Rezoning Application: PD 22-0877
Zoning Hearing Master Date: December 12, 2022
BOCC Land Use Meeting Date: February 7, 2023

The applicant is requesting a rezoning from CG to PD to accommodate the redevelopment of the property from a bank with a drive-through to a drive-through car wash.

AGENCY REVIEW COMMENT SHEET

DATE: 12/02/2022
AGENCY/DEPT: Transportation
PETITION NO: PD 22-0877

8.0 PROPOSED SITE PLAN (FULL)

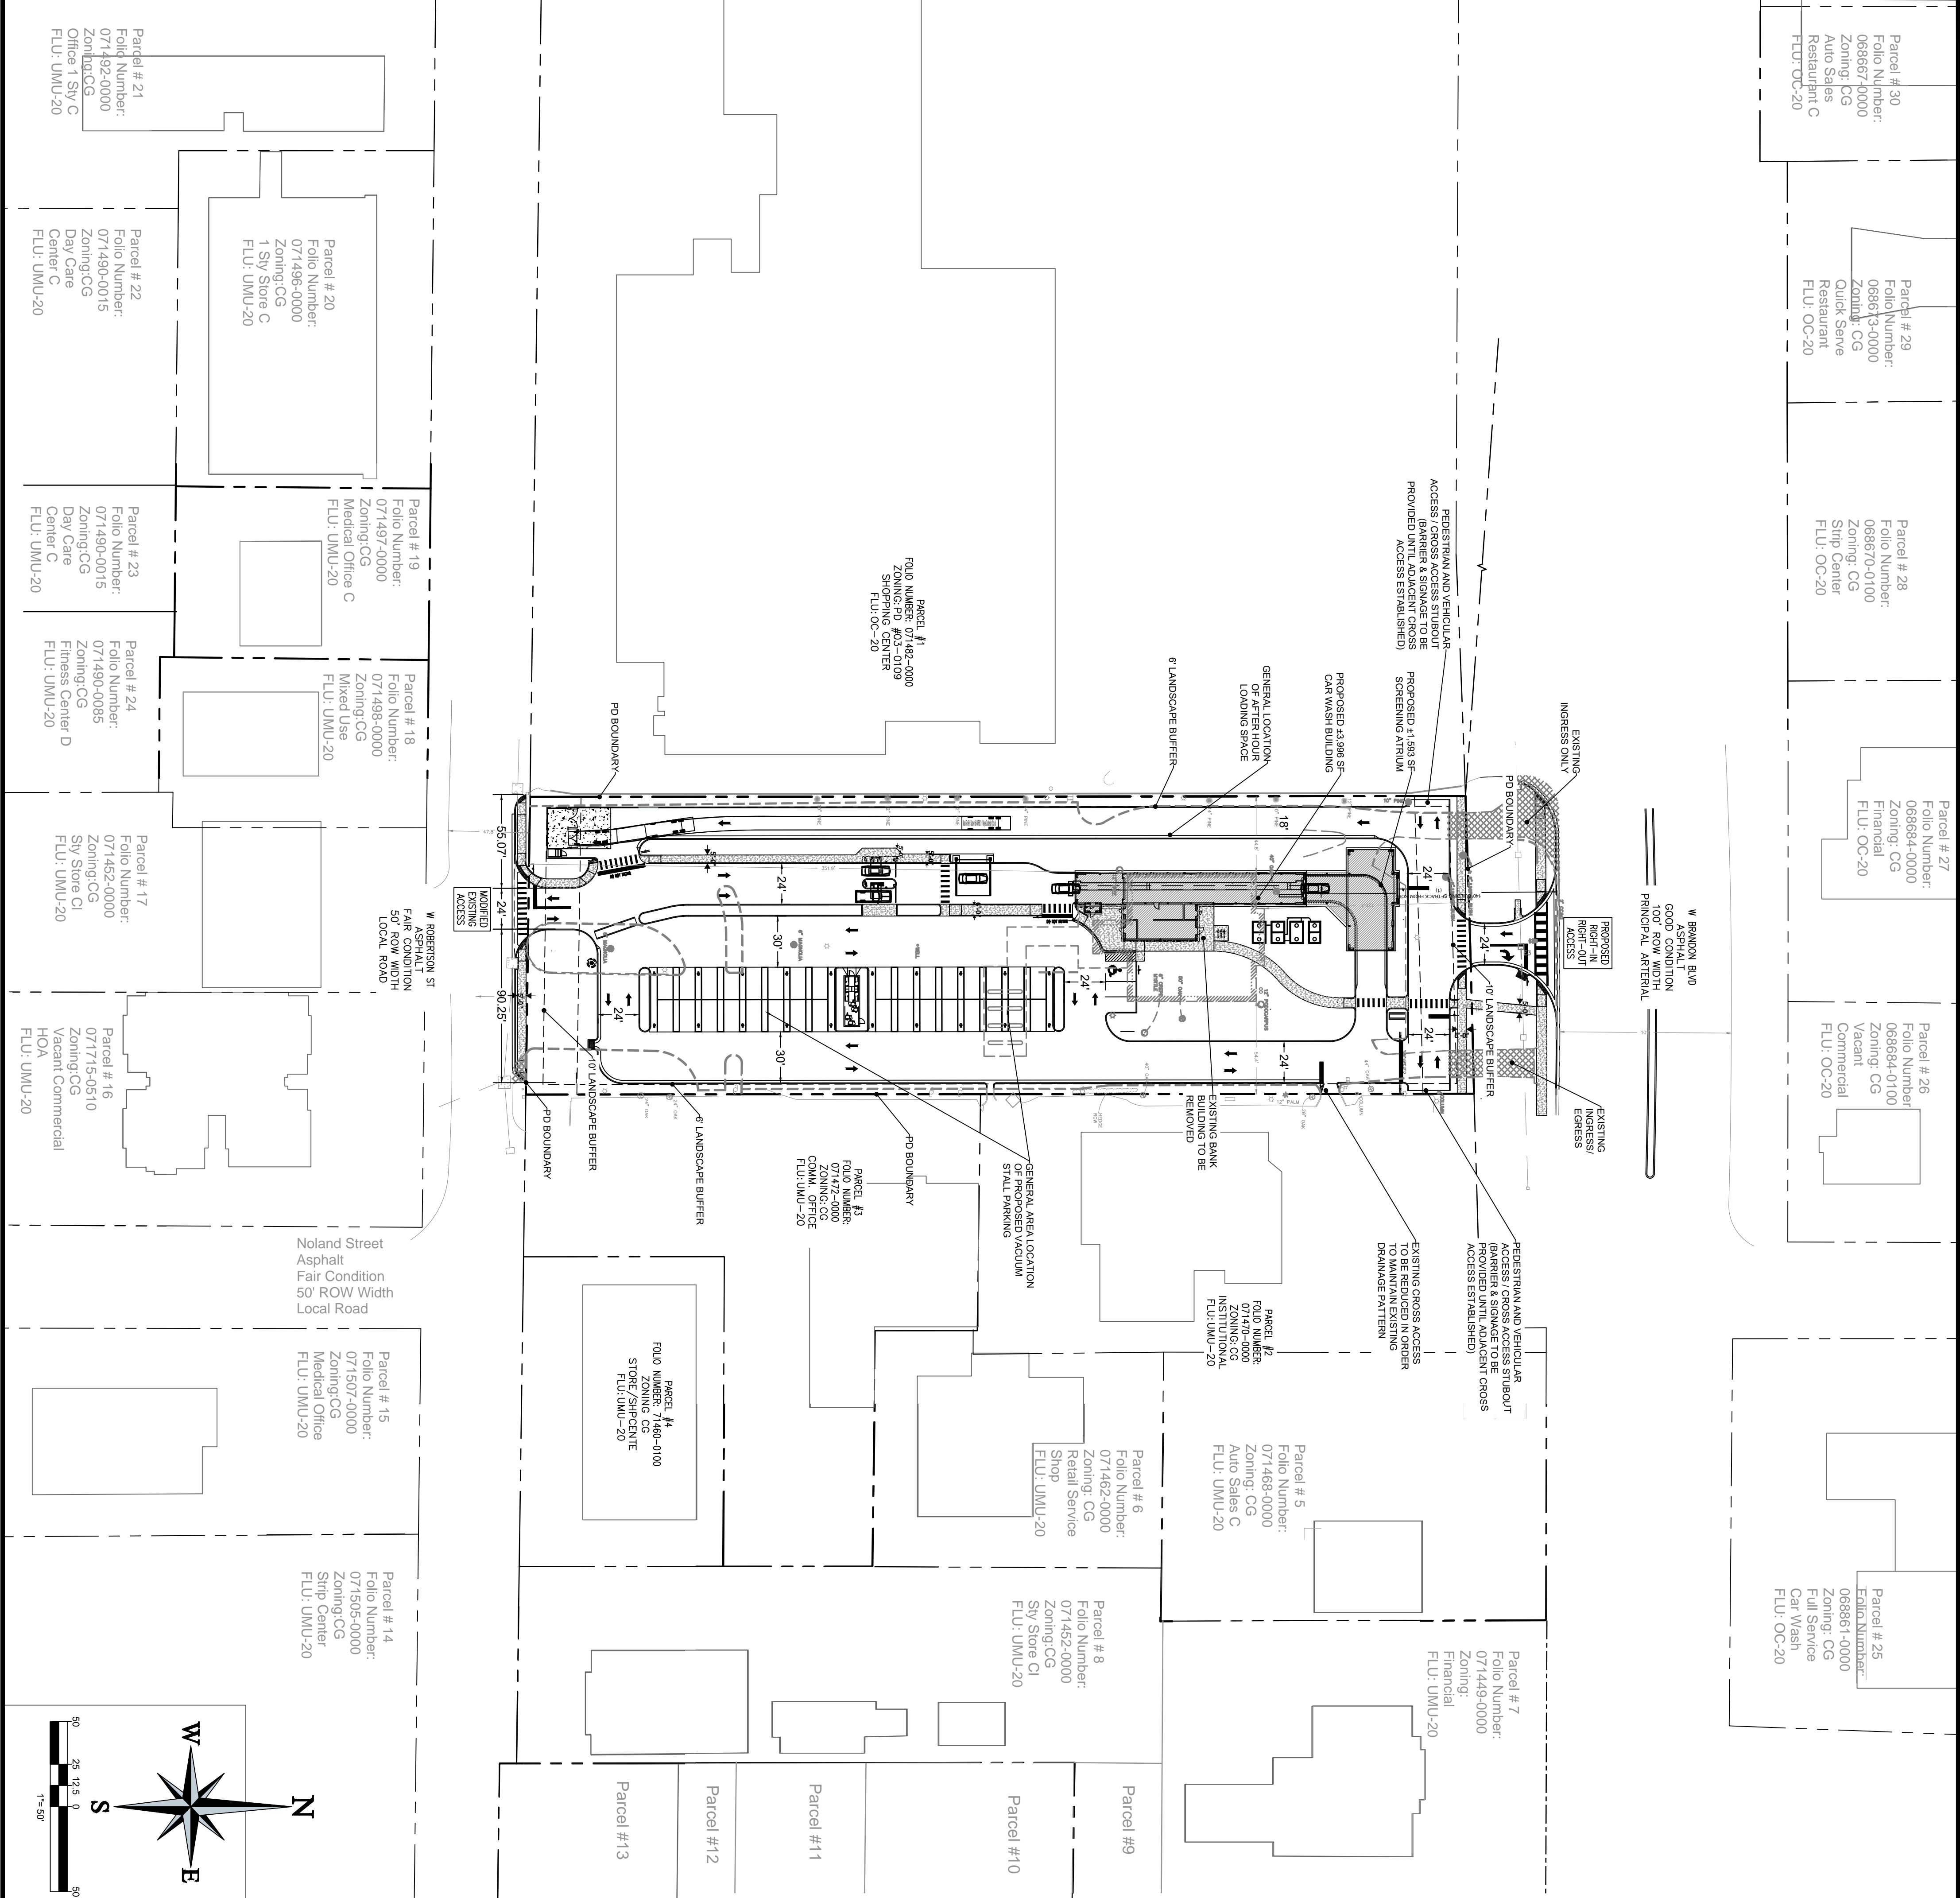
Prior to PD site plan certification, the applicant shall revise the PD site plan to:

- Revise the label on the site plan that reads “Proposed right in right out access” to read “Pedestrian and Temporary vehicular access - see conditions of approval”.
- Revise labels reading “existing egress” to read “existing access to be removed”.
- Revise the note that reads “EXISTING CROSS ACCESS TO BE REDUCED IN ORDER TO MAINTAIN EXISTING DRAINAGE PATTERN” to include information that no vehicular cross access will be allowed.

- Revise the label on the site plan that reads “Proposed right in right out access” to read “Pedestrian and Temporary vehicular access - see conditions of approval”
- Revise labels reading “existing egress” to read “existing access to be removed”
- Revise the note that reads” EXISTING CROSS ACCESS TO BE REDUCED IN ORDER TO MAINTAIN EXISTING DRAINAGE PATTERN” to include information that no vehicular cross access will be allowed.
